RE: Applicant Response to Comments Received on 01/13/2025 – 56th Avenue and Picadilly Road Marketplace at GVRE

Application Number: DA-1662-36

56TH & PICADILLY MARKETPLACE
SITE PLAN SET

VEHICLE CIRCULATION PLAN

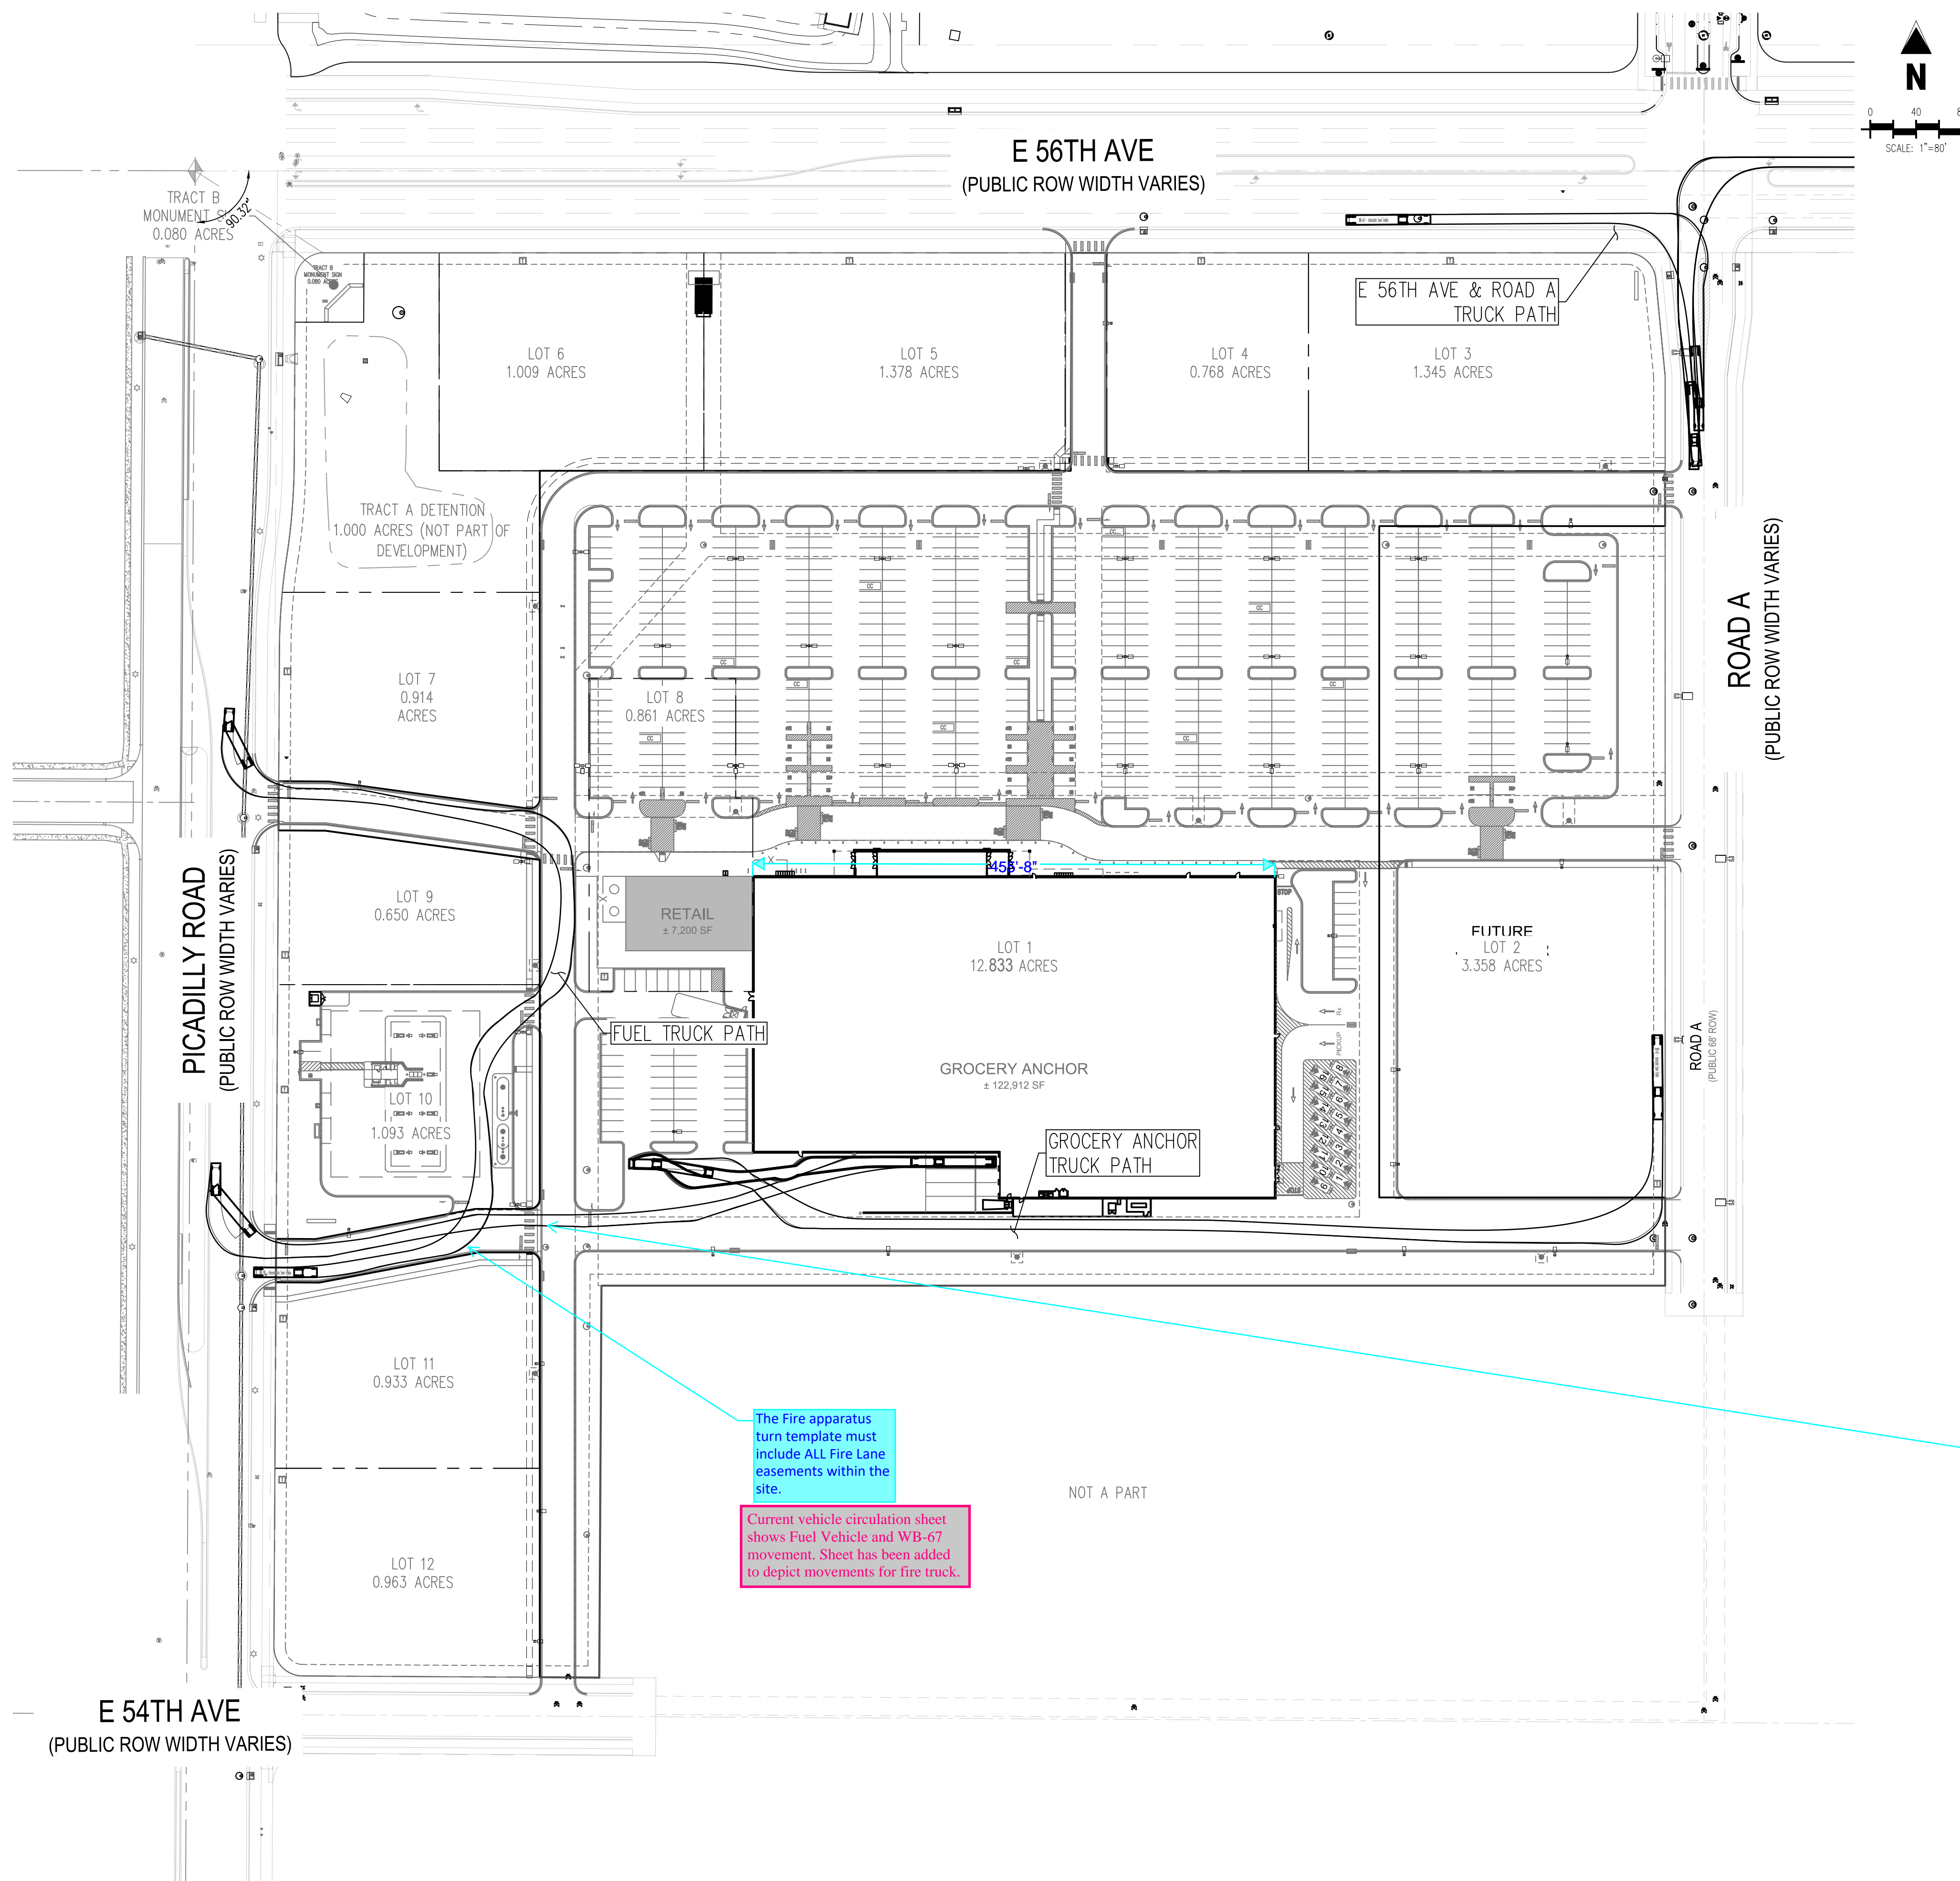
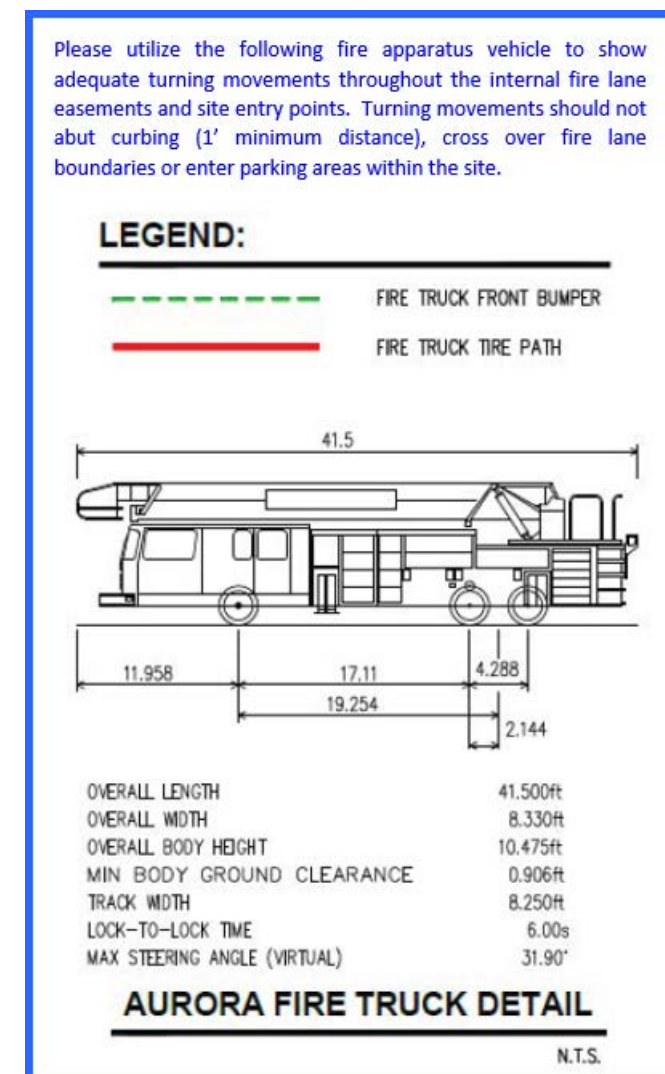
Please utilize a Fire Apparatus vehicle to show adequate turning movements throughout the internal fire lane easements and site entry points. Turning movements should not abut curbing (1' minimum distance), cross over fire lane boundaries or enter parking areas within the site.

Sheet has been added to depict movements for fire truck.

LANDSCAPE PLAN - S.E.

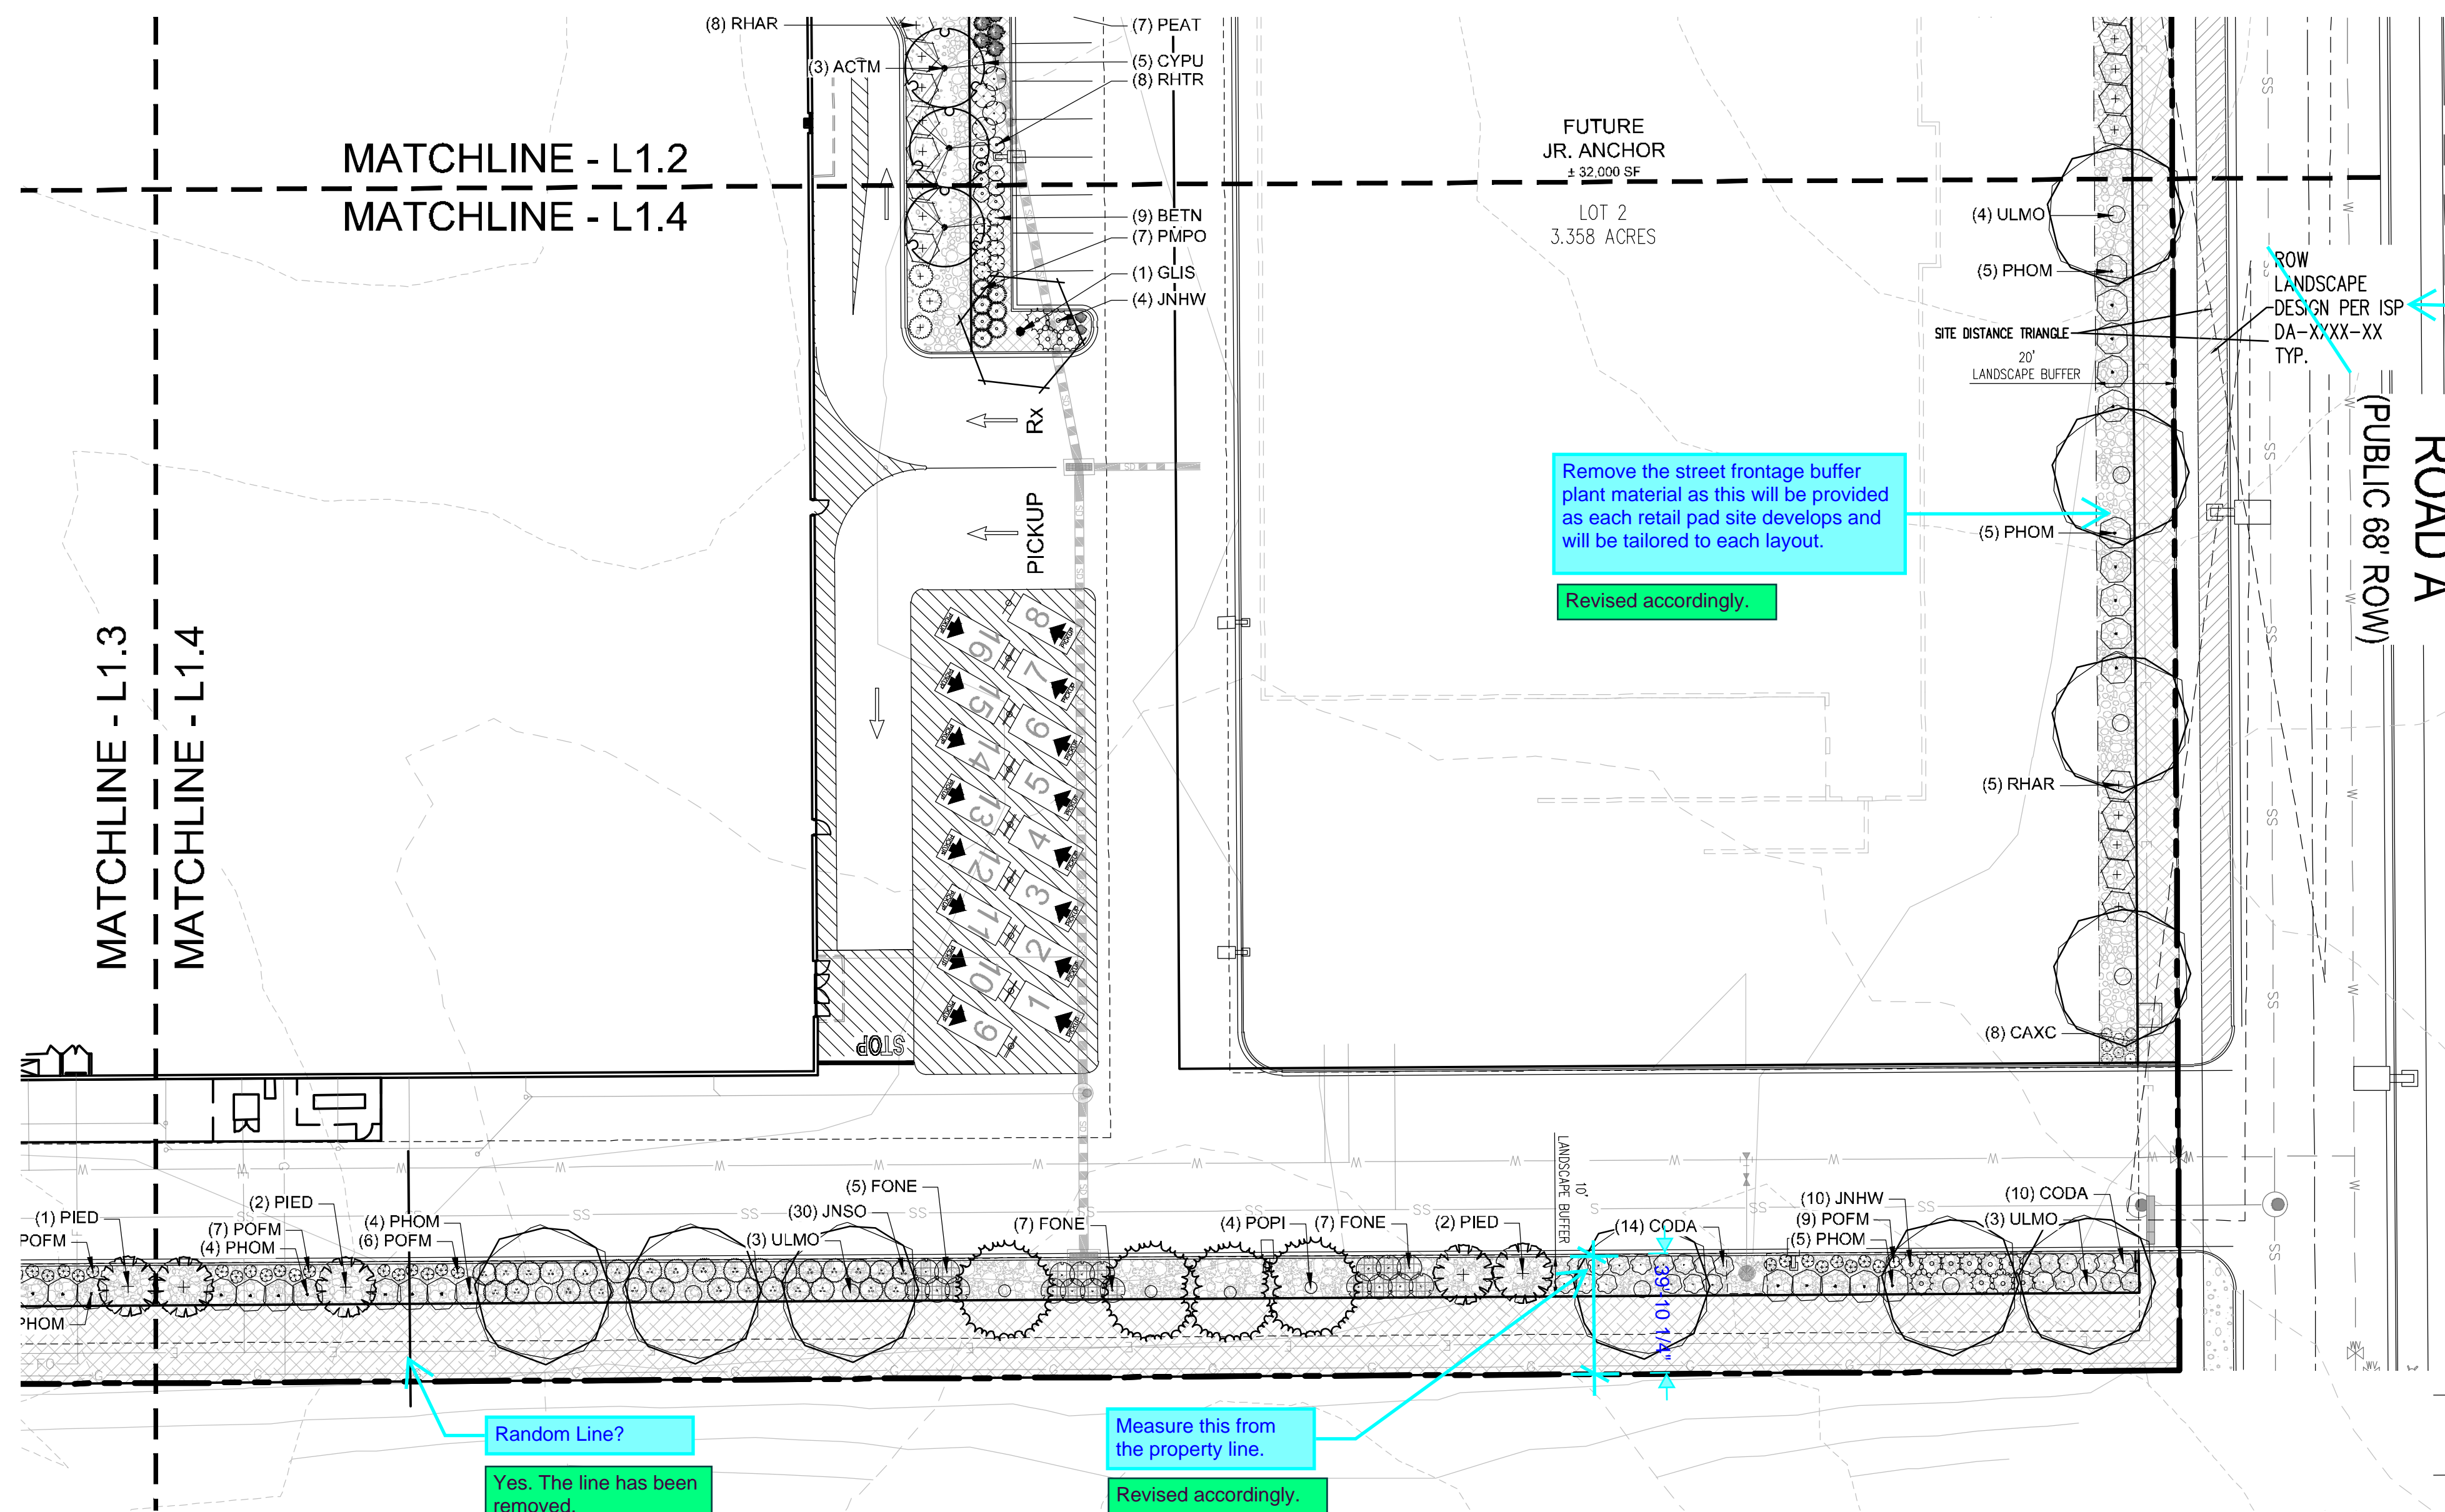
Please add the following note: ***For the curbside landscaping, refer to 56th and Picadilly Marketplace Offsite Improvement Site Plan - Infrastructure Site Plan. Case Number 2024-6052-00***

Please include a Symbol for the Fire Hydrants both proposed and existing in the legend.

Label has been updated.

Provided
